Manual 15

Biennial Review Changes

Jennifer Warner-Freeman
Members Committee
October 30, 2024

~~Exhibit 26: Name to be determined~~

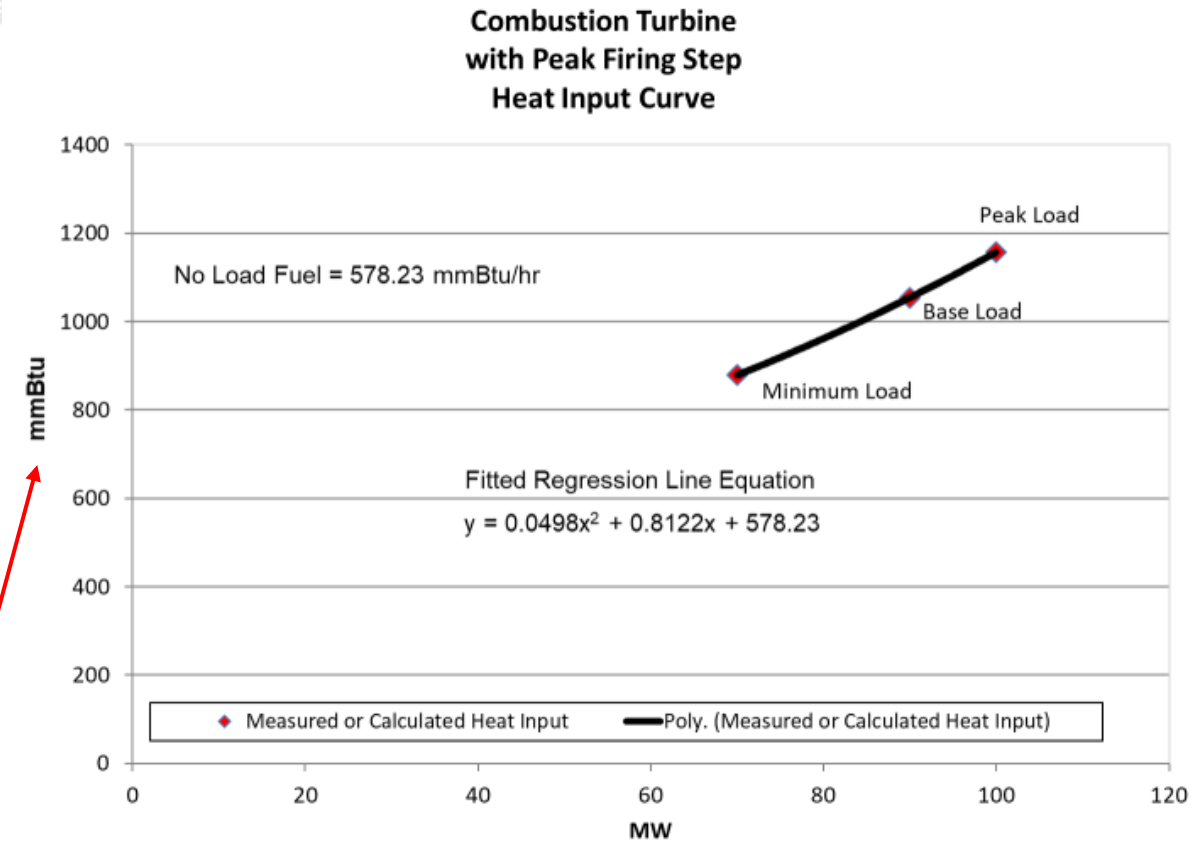
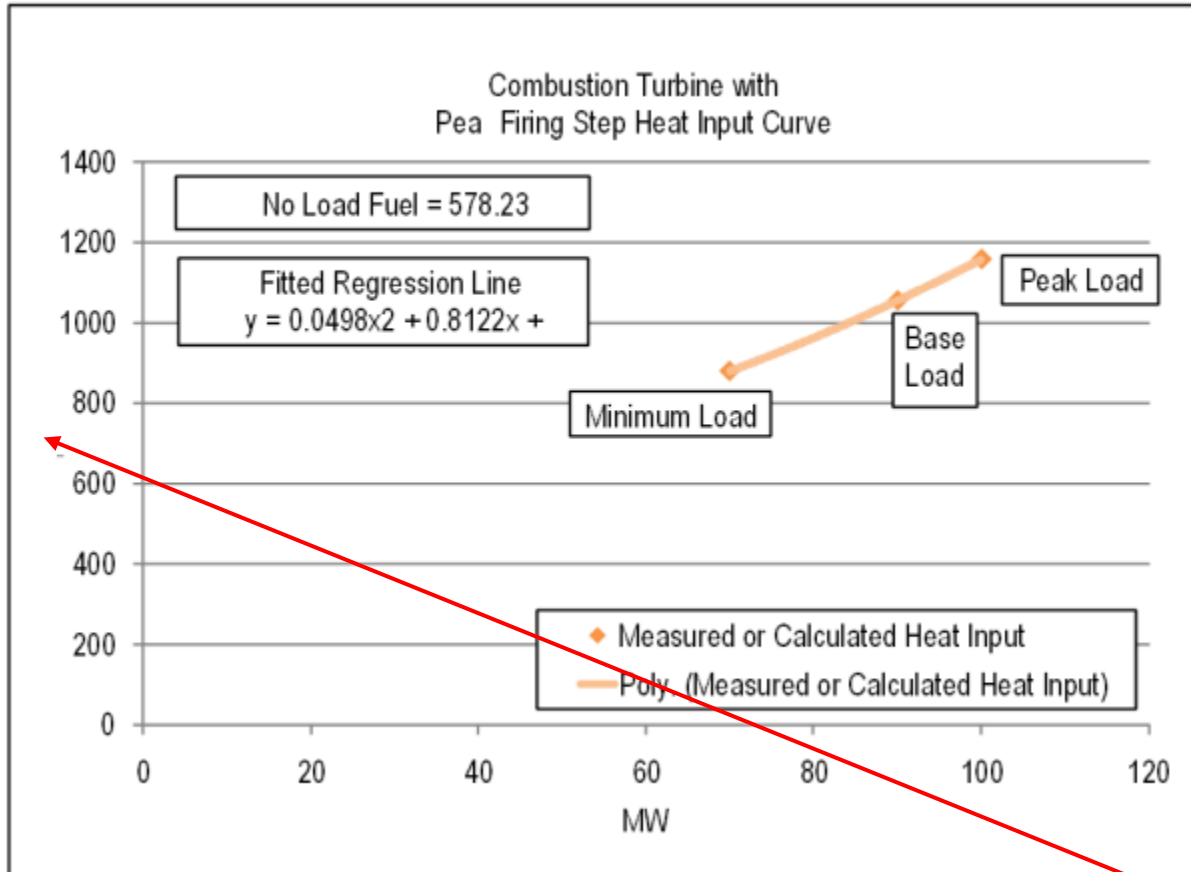
Replace any graphs with missing Y-axis labels
